MFN 07-582

Docket No. 52-010

**Subject: Response to Portion of NRC Request for Additional
Information Letter No. 100 Related to ESBWR Design
Certification Application - Safety Analyses – RAI Numbers
15.3-26, 15.3-29 and 15.3-33**

DCD Markups

Figure 15.1-12. Event Diagram – Control Rod Withdrawal Error During Power Operation

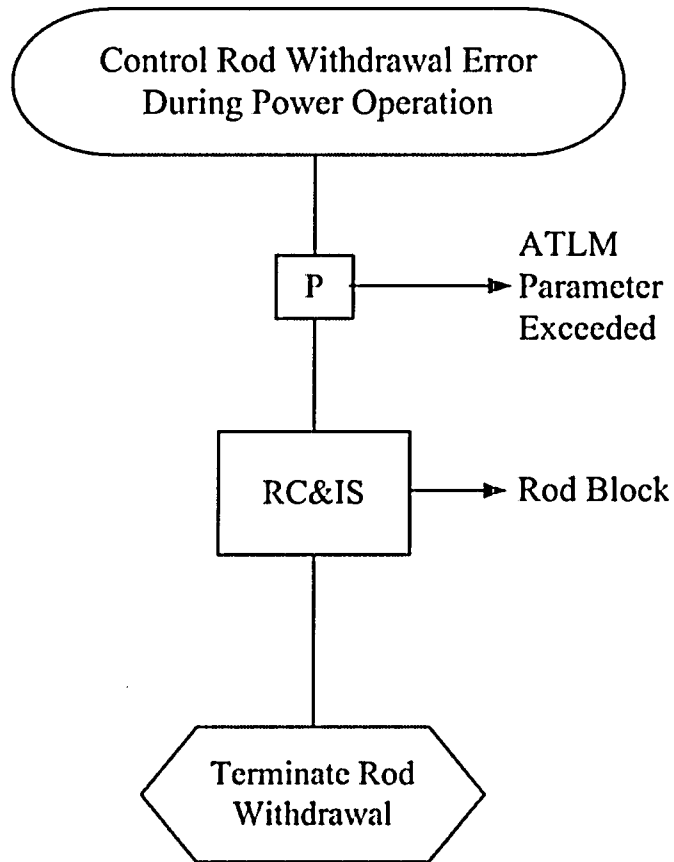
Control Rod Withdrawal Error During Power Operation, DCD 15.3.9.4 states: "An evaluation of the barrier performance is not made for this event, because there is no postulated set of circumstances for which this event could occur."

The current version of the SRP requires that RWE be analyzed as an AOO. The additional system in the ESBWR is supposed to prevent RWE but the estimated frequency is considerably smaller than 1.0E-02, it is finite and accounts for ATLM failure. Other transients, an example being 15.3.6 with an estimated frequency in the same order of magnitude as this one were analyzed, and therefore the staff believes that the RWE transient should be analyzed. Provide your analysis of this event.

The DCD will be revised to include two sets of RWE-during-power-operations: one for the AOO and the other for an IE that includes ATLM failure.

DCD Tier 2, Sections 15.0, 15.1, 15.2, and 15.3 changes will be included in DCD Tier 2, Revision 5, as noted on the attached markups. Sections 15.2 and 15.3 show the new or revised events, and Sections 15.0 and 15.1 shows the updated figures and tables that refer to these events.
